ORDINANCE NO. 586

AN ORDINANCE OF THE CITY OF WILSONVILLE APPROVING A PRELIMINARY DEVELOPMENT PLAN AND A ZONE MAP AMENDMENT FROM THE CLACKAMAS COUNTY EXCLUSIVE FARM USE (EFU) ZONE TO THE CITY OF WILSONVILLE VILLAGE (V) ZONE ON APPROXIMATELY 33.17 ACRES WITHIN VILLEBOIS VILLAGE OF TAX LOT 500, SECTION 15, T3S, R1W, CLACKAMAS COUNTY, OREGON. THE LEGEND AT VILLEBOIS, LLC, APPLICANT.

RE: Second Reading of Ordinance 586, Zone Change for Phase I of Villebois SAP East

REVISED PLAN

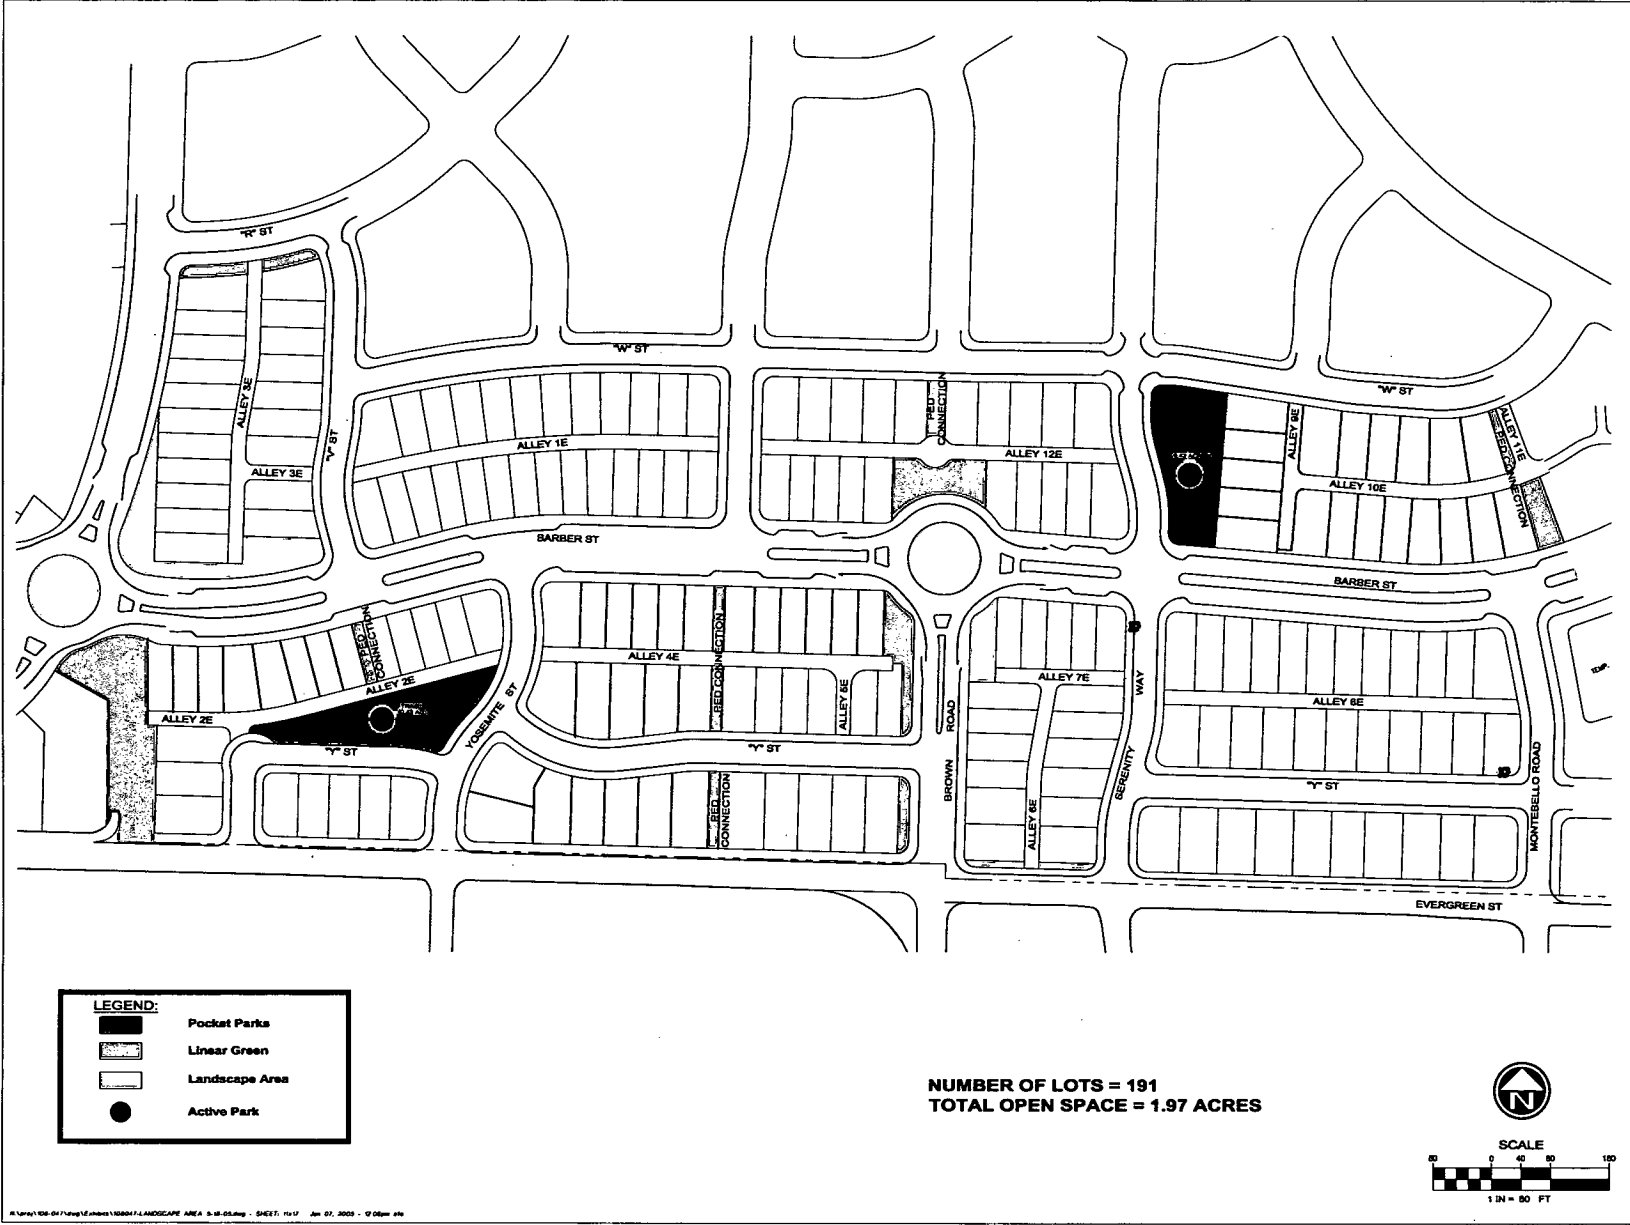
Council's consideration of Ordinance 586 on May 16, 2005 provided feedback on a revised preliminary development plan (PDP) provided by the applicant as well as a plan proposed by staff. Attached is a revised (PDP) from the applicant. Compared to the plan presented on the May 16th, this plan provides more park space (.42-acre pocket park), three additional pedestrian connections, and seven (7) fewer lots. Staff's comments and recommendations on the plan follow below.

The applicant's revised plan dedicates five (5) lots in northeast corner of the PDP, or .42 acres, to an additional park in the northeast quadrant of the plan. This park is slightly less than a half (1/2) acre in size, is bounded by local streets and an alley on three sides, and, would provide a park with active recreation for approximately every 96 lots of PDP I (in conjunction with the .43 acre park in the southwest portion of the site).

The applicant's revised PDP depicts a pedestrian crossing between the two blocks bounded by Brown Road and Yosemite Street and south of Barber Street. This crossing would bring all of the block lengths into compliance with the Development Code's requirement of 530 feet maximum distance between streets for local access (W.C. 4.125(.05)A.2.). Staff notes that the pedestrian connection previously depicted on the east side of Alley 9E has been removed. According to the applicant, a sidewalk will be installed, directly east of the new proposed park that would replace the function of the pedestrian connection.

4. The park bounded by "W" Street, Serenity Way, and Barber Street shall be programmed for active park use. The applicant shall prepare plans sufficient for the City's Parks and Recreation Advisory Board to determine the programmed uses and shall present these plans to the PRAB at a regularly scheduled meeting for their recommendation on the proposed use of the park. Planning Division staff shall not approve the revised FDP until a positive recommendation is obtained from the PRAB.
5. The applicant shall work with staff to identify opportunities, if any, through the development of a revised grading plan to preserve existing trees of moderate to good health in the vicinity of the Kirkendal home site.

From the Grading and Erosion Control Plan – Sheet 6 from original PDP submittal

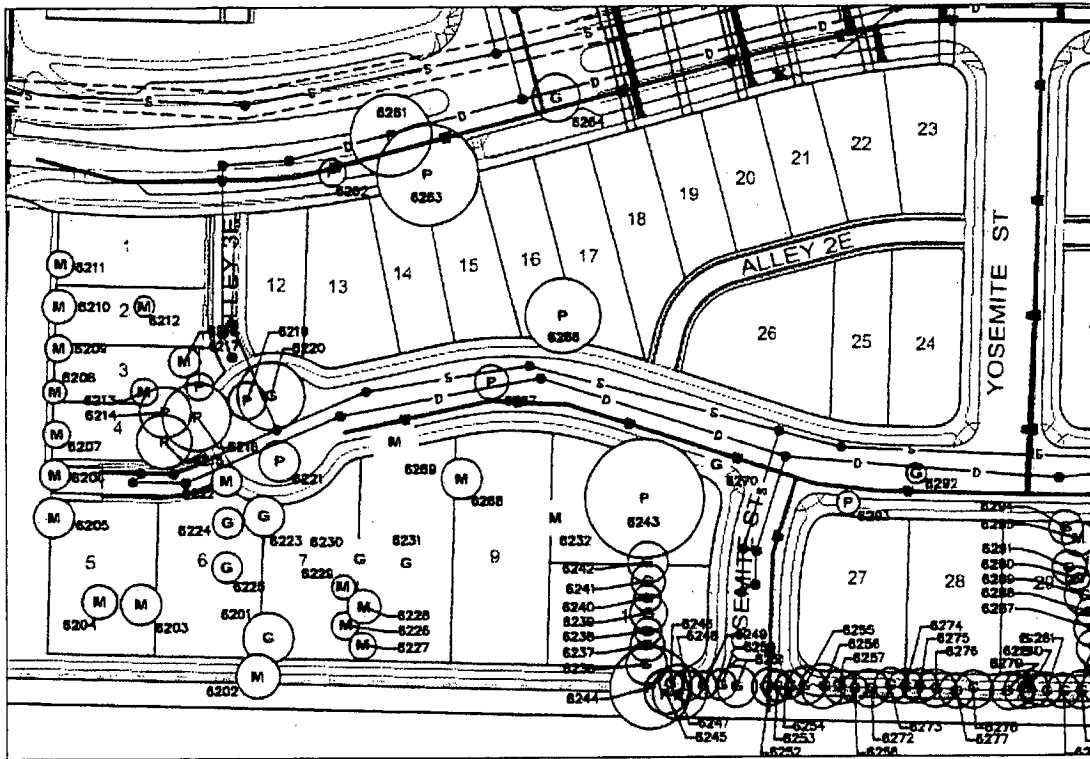
Council also expressed a desire to protect existing trees near the Kirkendal homestead. The DRB approved the Type C Tree Removal Plan in Planning Case File DB-2005-02-0016 wherein the majority of the trees in this area were approved for removal. It would appear the reason for the removal of the majority of these trees is due to the grade changes which range from approximately four (4) to six (6) feet in this area (see graphics below). This grading plan, along with the majority of the other plans associated with the PDP, will need to be revised to reflect the PDP ultimately approved by Council. Even with these revisions, the grade changes in this area

will likely be driven to a large extent by the grades needed for Barber Street and its connections to adjacent roads. Through the development of revised plans, the applicant will need to evaluate opportunities to save existing trees in this area. See condition of approval 5.

REVISED PDP PLAN

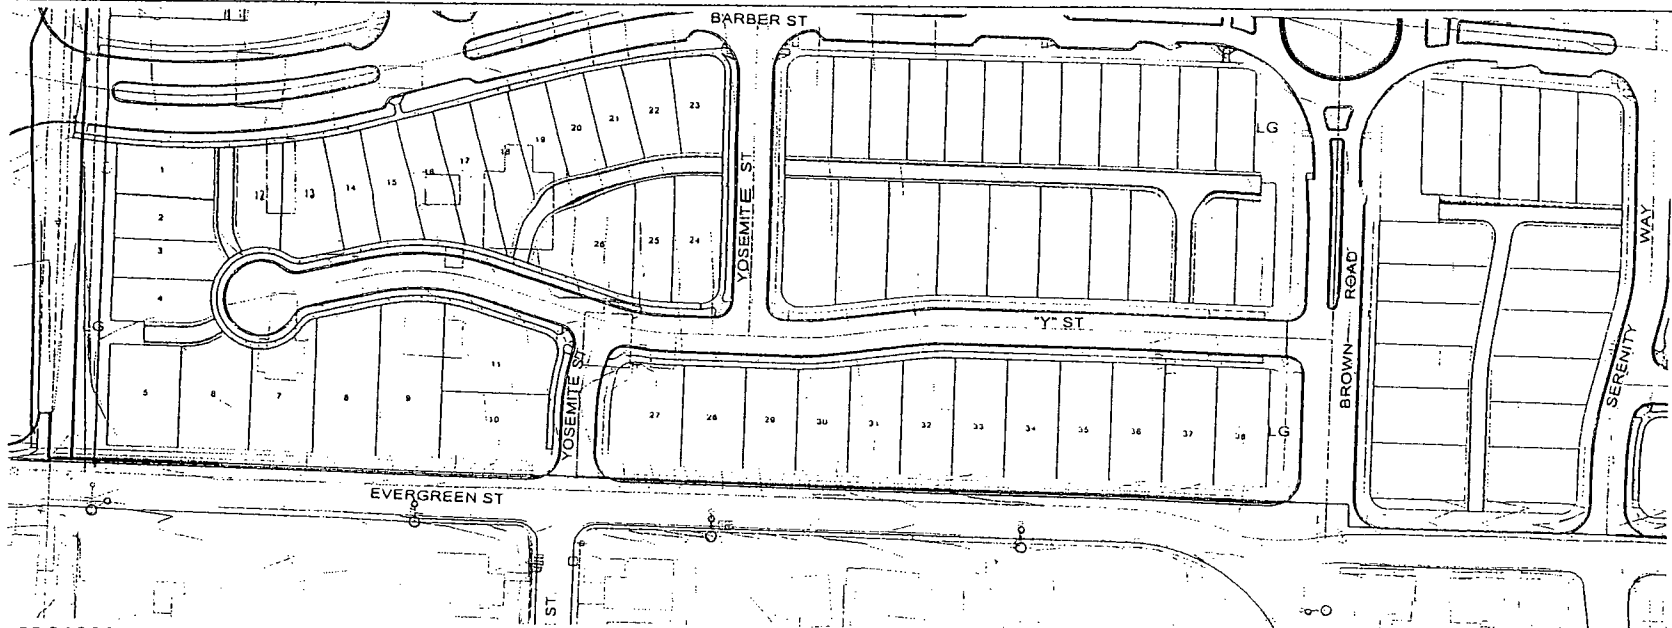
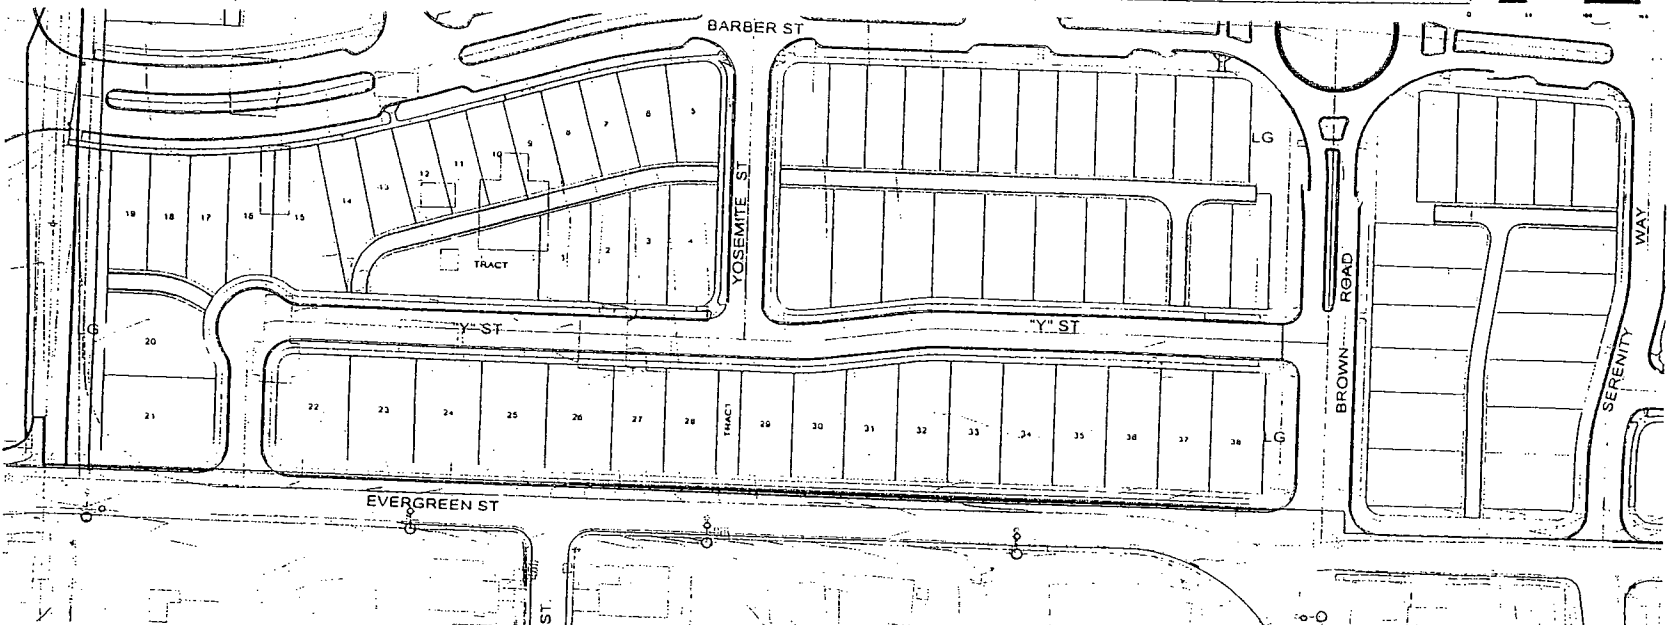
Condition of approval 2 of Planning Case File DB-2005-02-011 (PDP) required the applicant to redesign the PDP to reflect DRB and Staff concerns regarding street alignments. The applicant presented the DRB with a redesigned plan at the March 28th hearing that satisfied, in concept, these concerns. The DRB directed Staff to review the finer details of the redesigned plan and all related plans (tentative plan, final development plans, Type C tree removal, etc.) to ensure that these plans met the concept approved by the DRB. Staff suggests that a similar process be used with the subject application: Council approve the revised PDP and allow staff review of the plans that need to be updated based on the revised PDP. Staff is proposing Council adopt condition of approval no. 3 and allow staff review of revised plans.

Park Additions

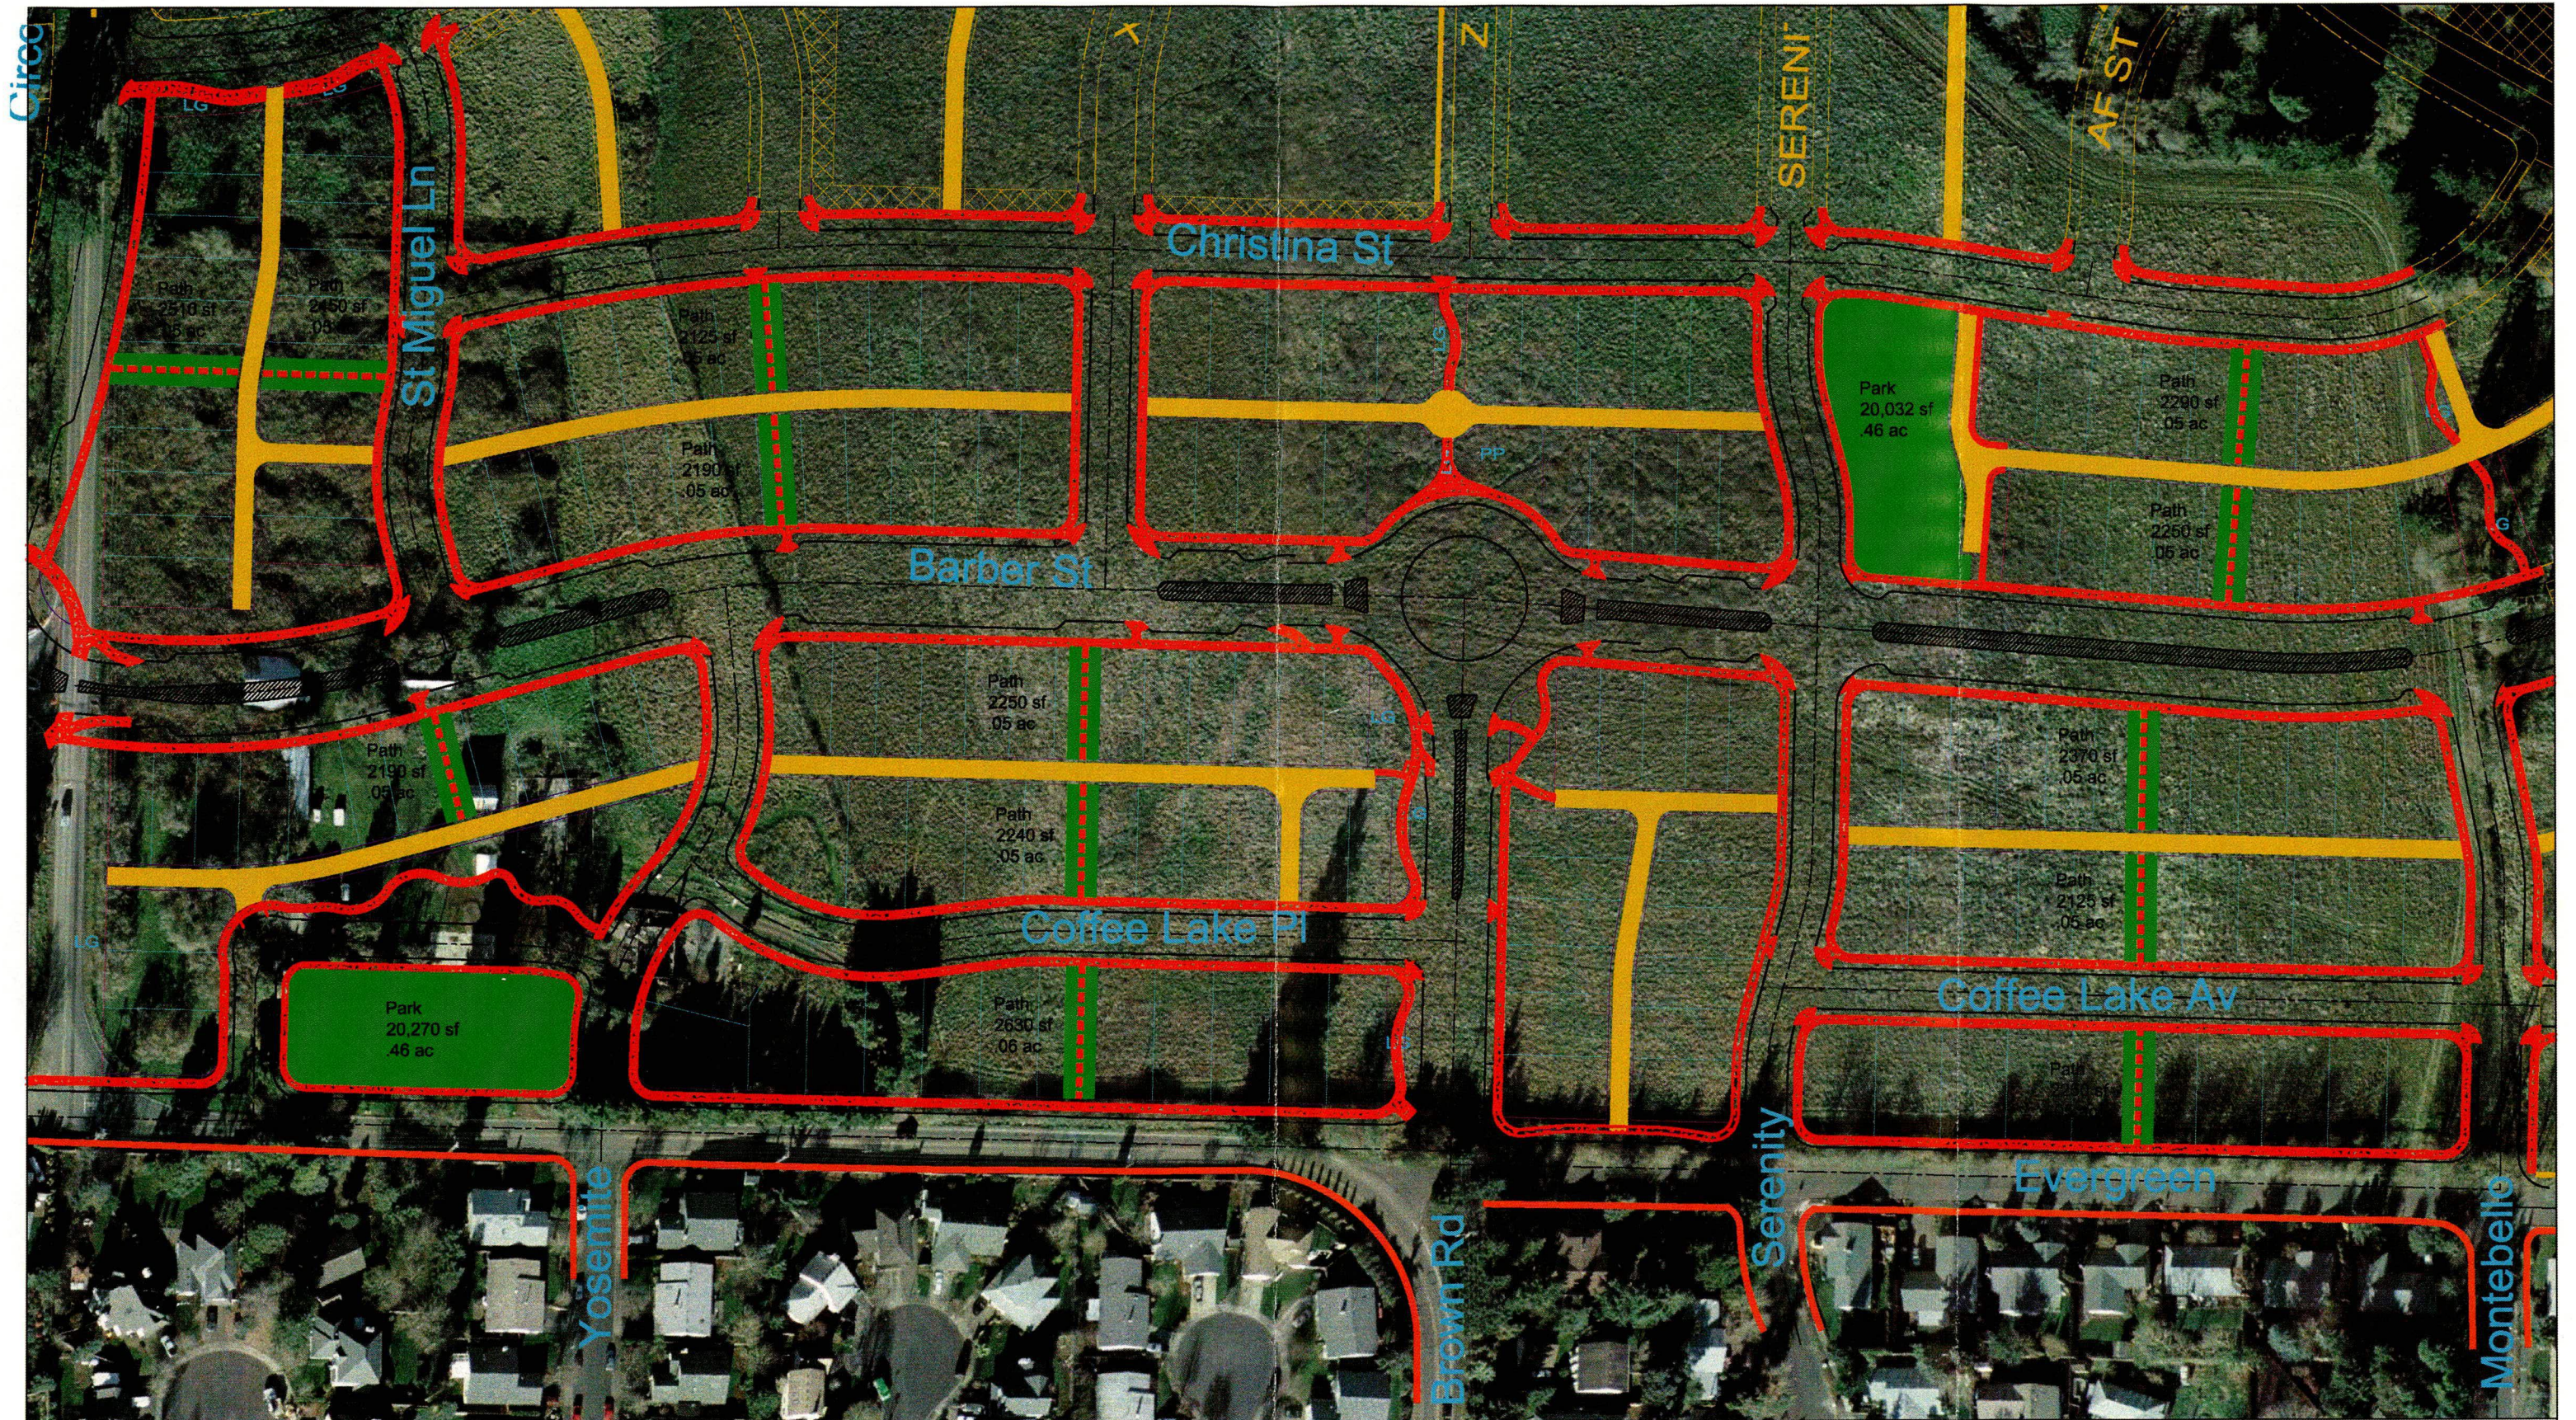
- Installation of an additional pocket in the block east of Serenity Way and north of Barber Street.
- Installation of a pocket park with opportunities for active recreation including playground equipment in the block west of Yosemite, north of Evergreen, and east of Y Street. This would replace the pocket park currently proposed west of Yosemite and north of Y Street. See below.

Installation of these parks would eliminate the need for the temporary park east of Brown Road.
